**In the Matter of:**  
**PR Spring Tar Sands Project**  
**February 15, 2011, Ground Water Discharge Permit-by-Rule**

**INDEX OF INITIAL RECORD**

**January 10, 2012**

**Figure 4a**  
**Earth Energy Resources Inc. - PR Spring Oil Sand Mine**  
**Transverse Mine Section W1-E1 Rev.3**

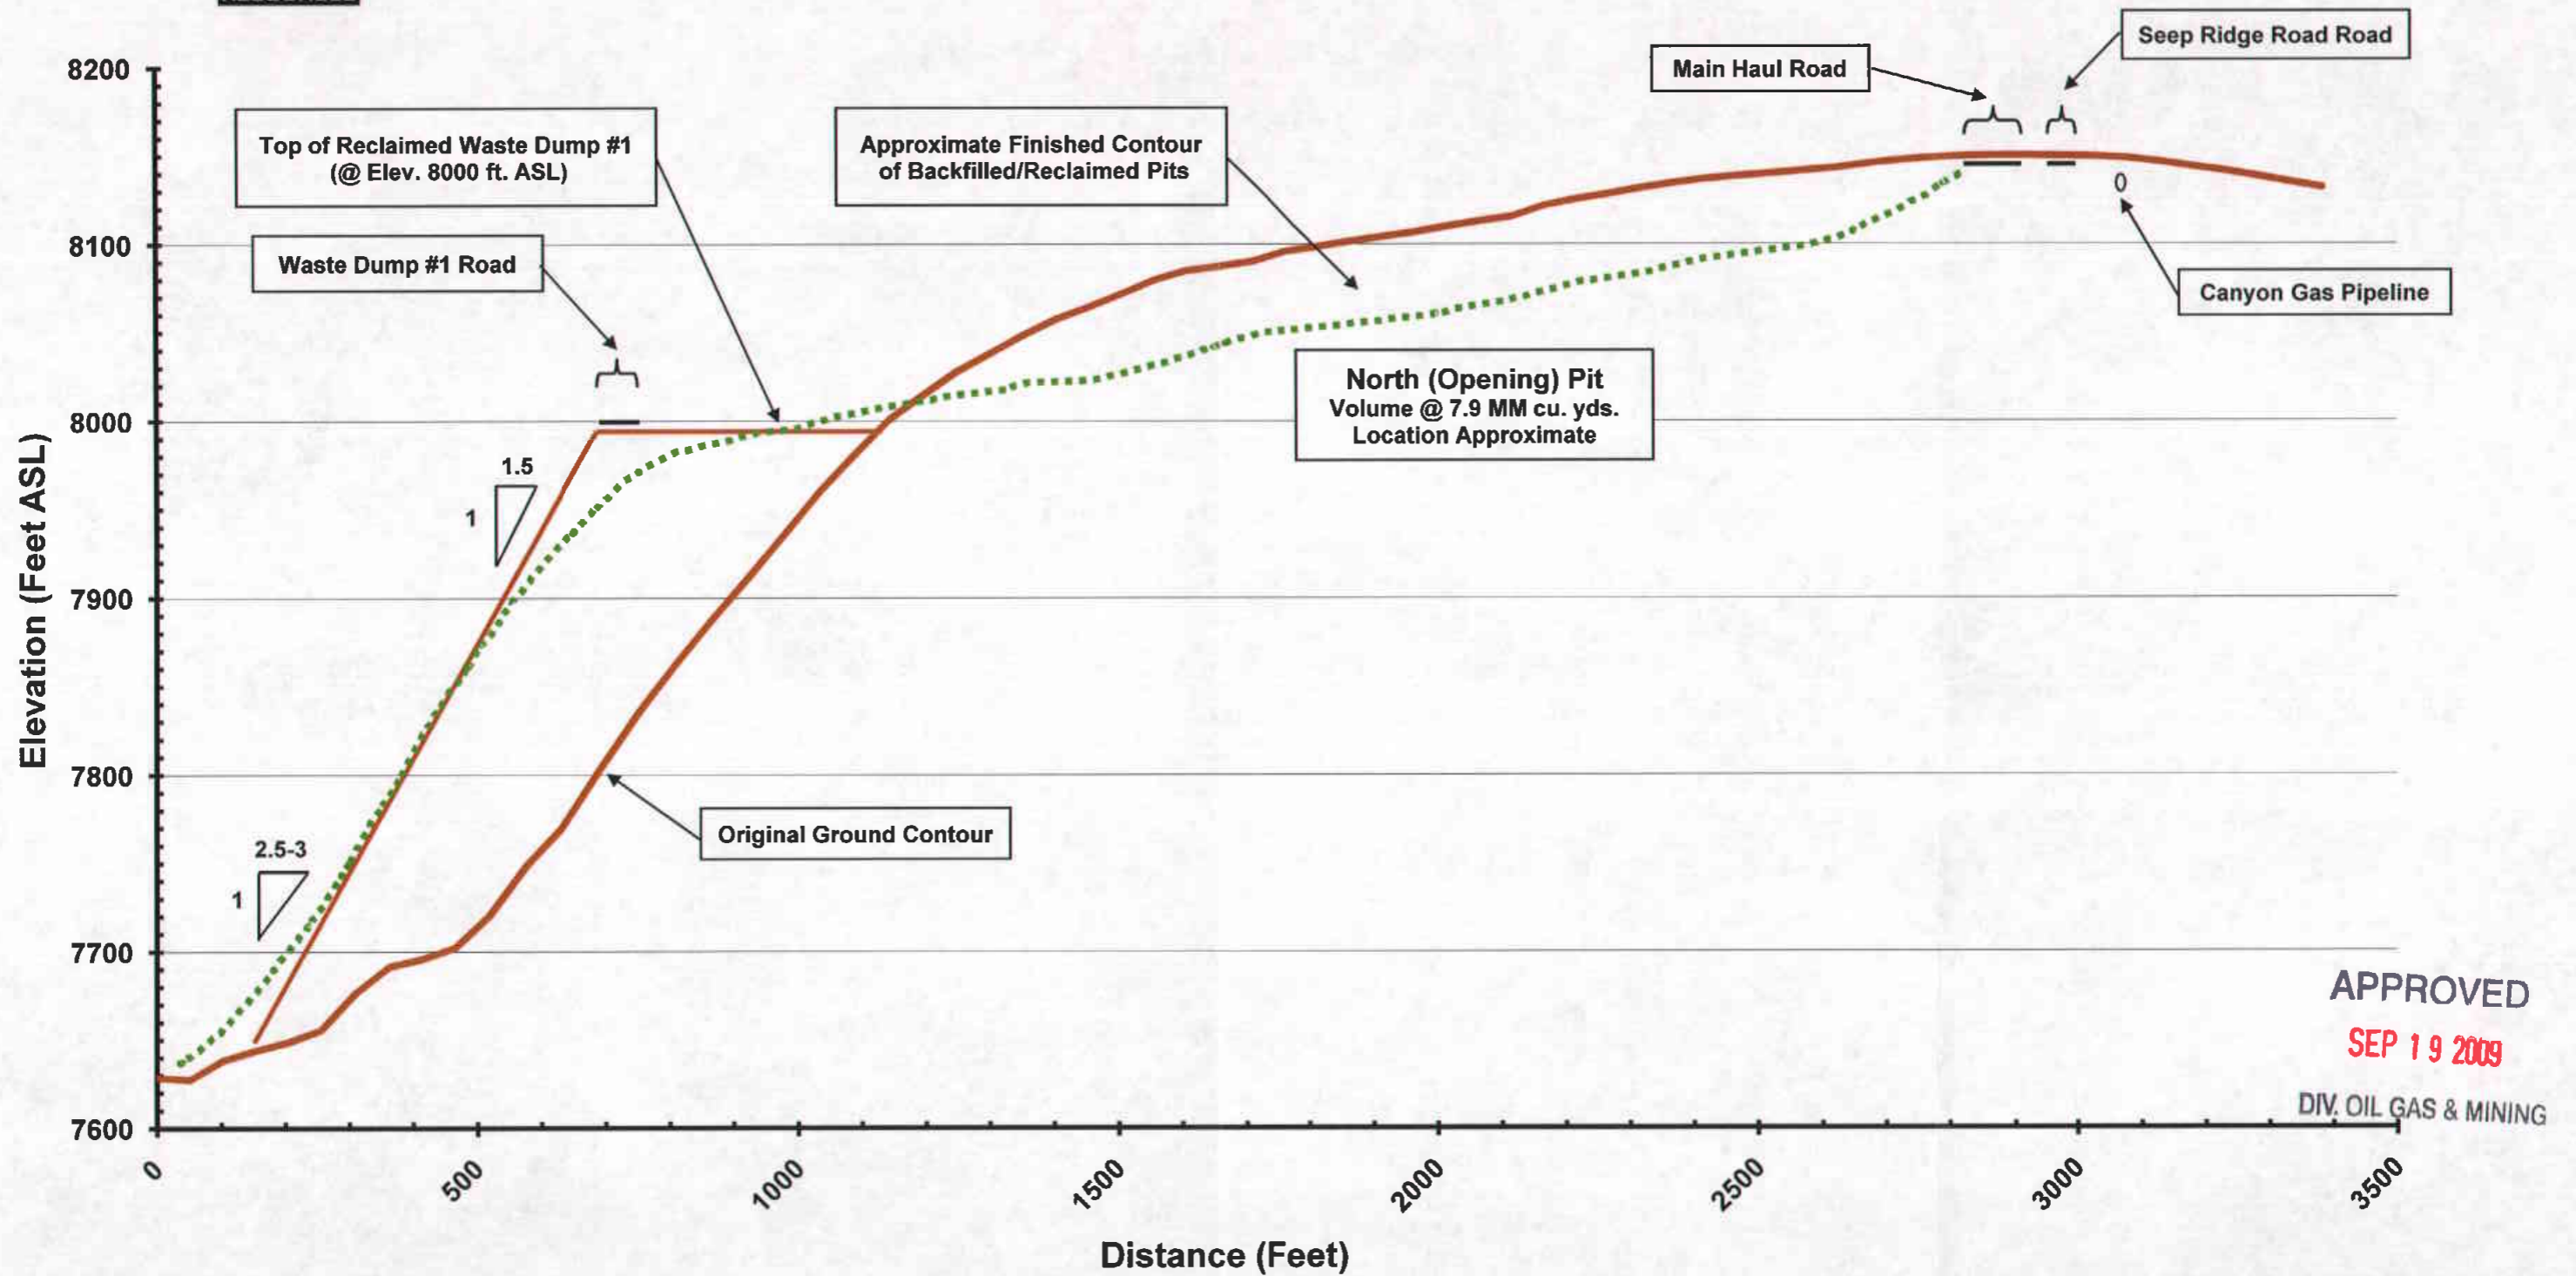
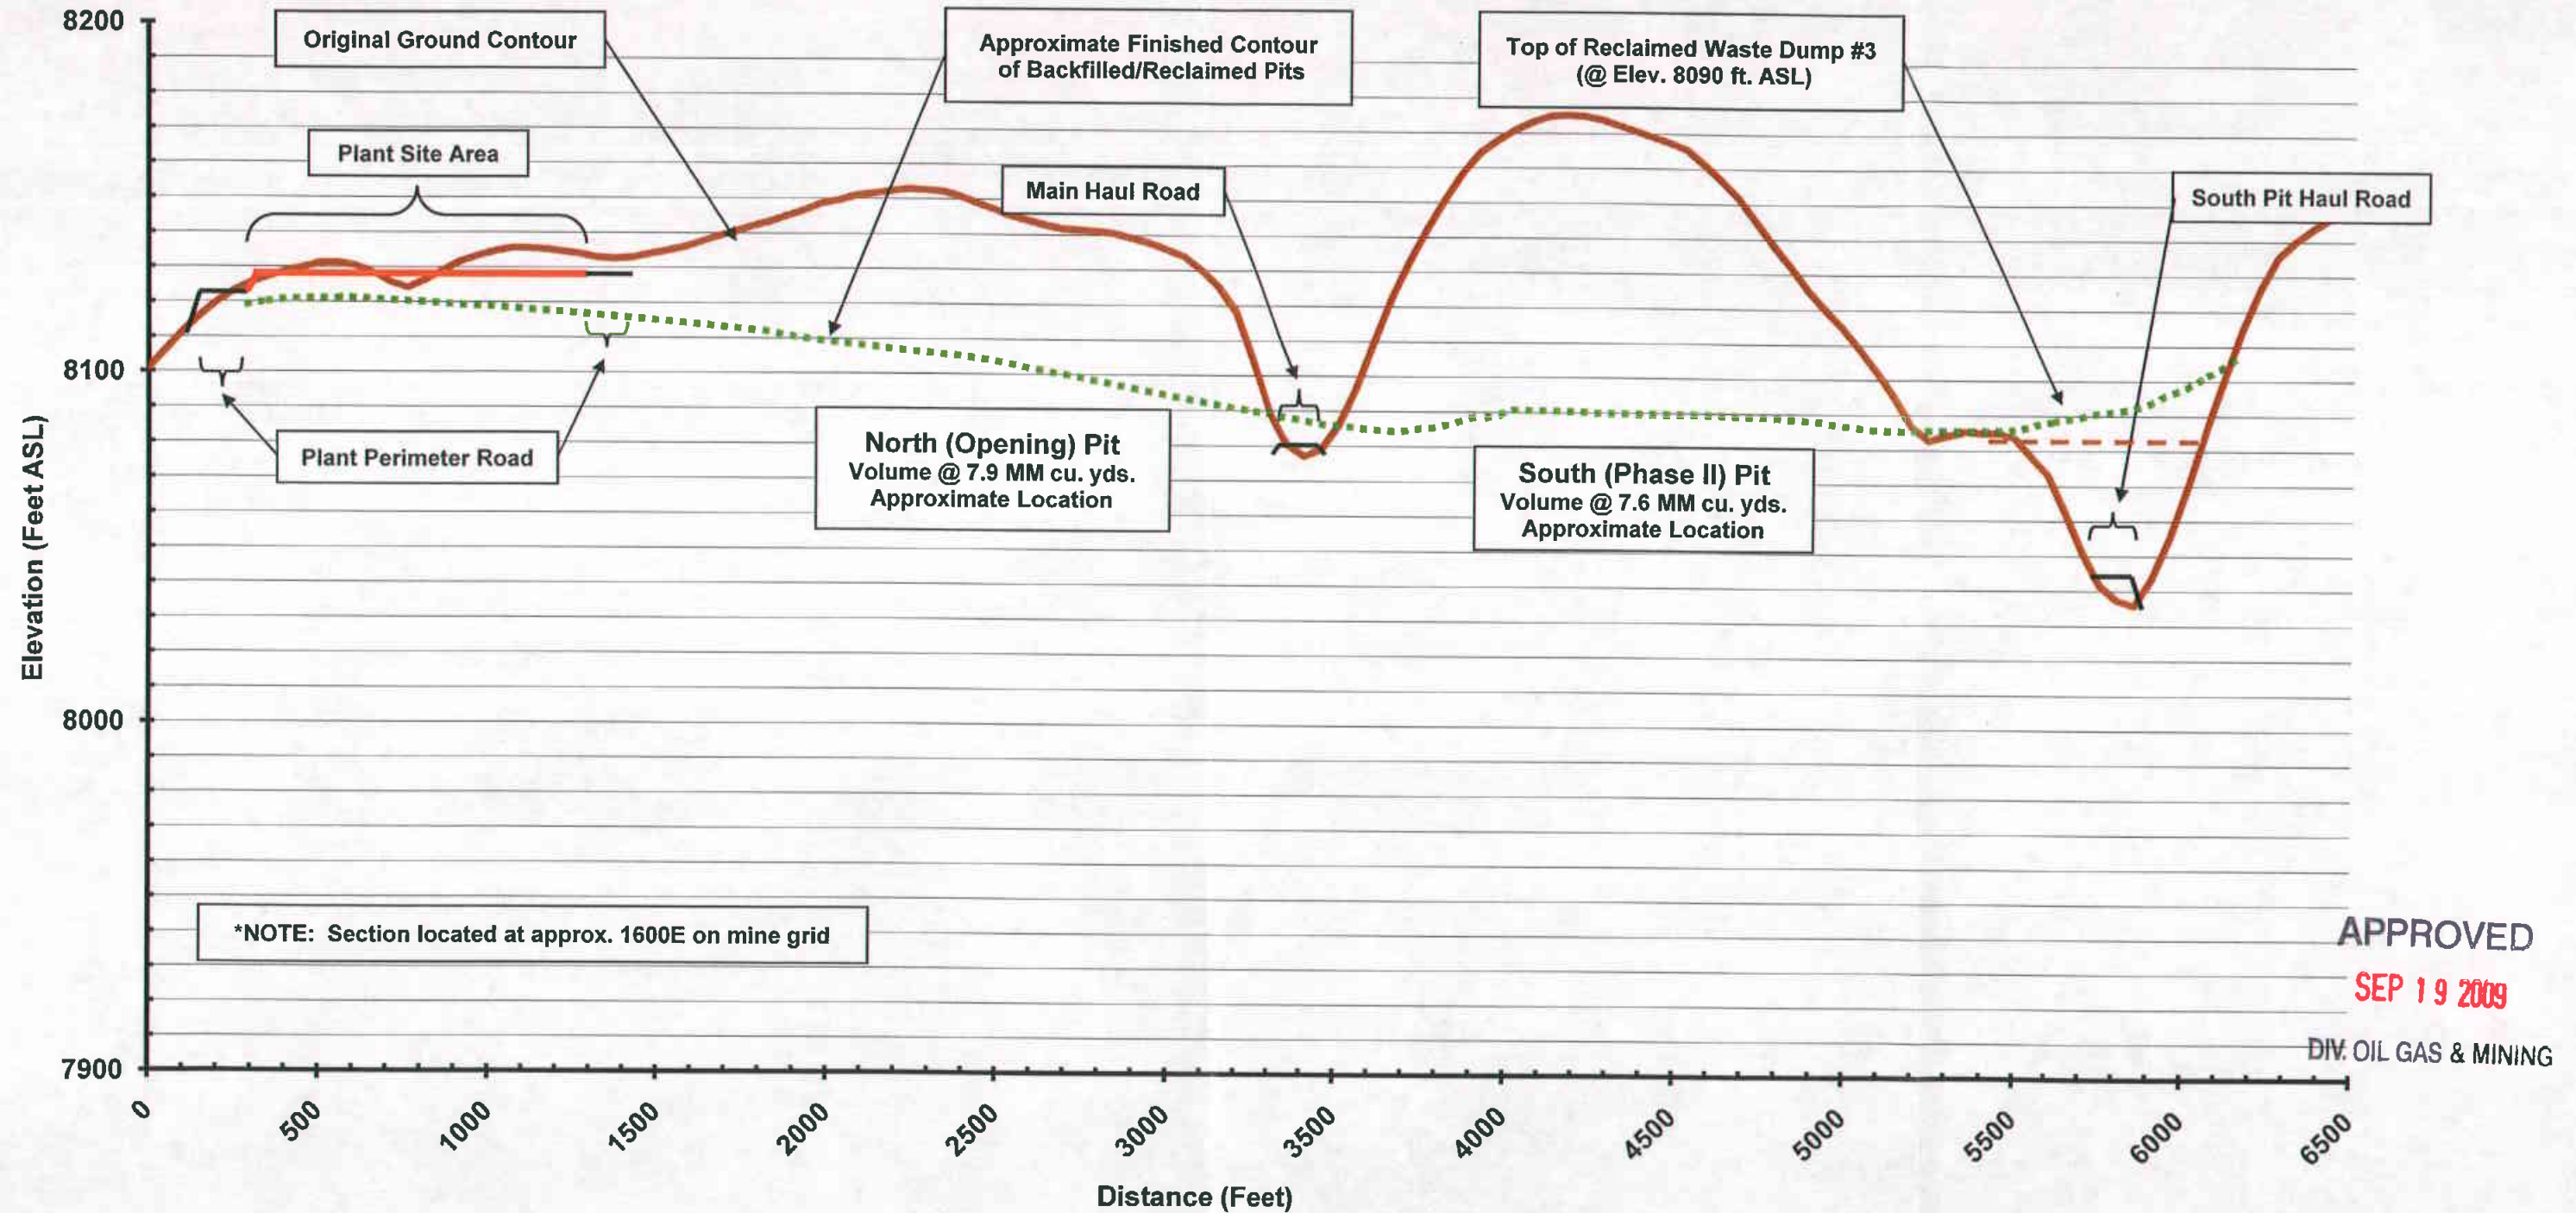
14	Figure 4a,4b,4c,6	FYI only, best if drawn with no vertical exaggeration, best if all x-sections are the same scale, engineering standards for drawing are lacking (lah)	A	Earth Energy respectfully disagrees that these cross sections are best shown without vertical exaggeration. Necessary detail would be lost if scales were equivalent, and vertical exaggeration is a standard practice to solve this problem. No changes to the scale of these drawings have been made.
15	Figure 4a,4b,4c	Slope angles shown on x-section are incorrect. (lah)	A	Earth Energy believes that the shown slope angles on all three of these figures are correct. Please note that a replacement for Figure 4b was submitted to the Division on May 15, 2008 to correct an error in the May 2008 2 <sup>nd</sup> draft NOI submittal.
16	Figure 5	As per 105.3.16 A geology map is required, include Geomechanical data; include orientation of bedding and structural features include faults, and joint sets orientations to demonstrate pit wall stability . (lah)	B	In response to a comment in the Division's Initial Review, the best available geologic map was provided as Figure 5 in the May 9, 2008 2 <sup>nd</sup> draft NOI. The response letter accompanying that 2 <sup>nd</sup> draft stated that it was the best available map. As requested by Comment # 40, generalized strike/dip information for bedding has been added to Figure 5. The other more detailed geologic information that the Division is requesting is simply not available, to Earth Energy's best knowledge, so it cannot be added to the map.
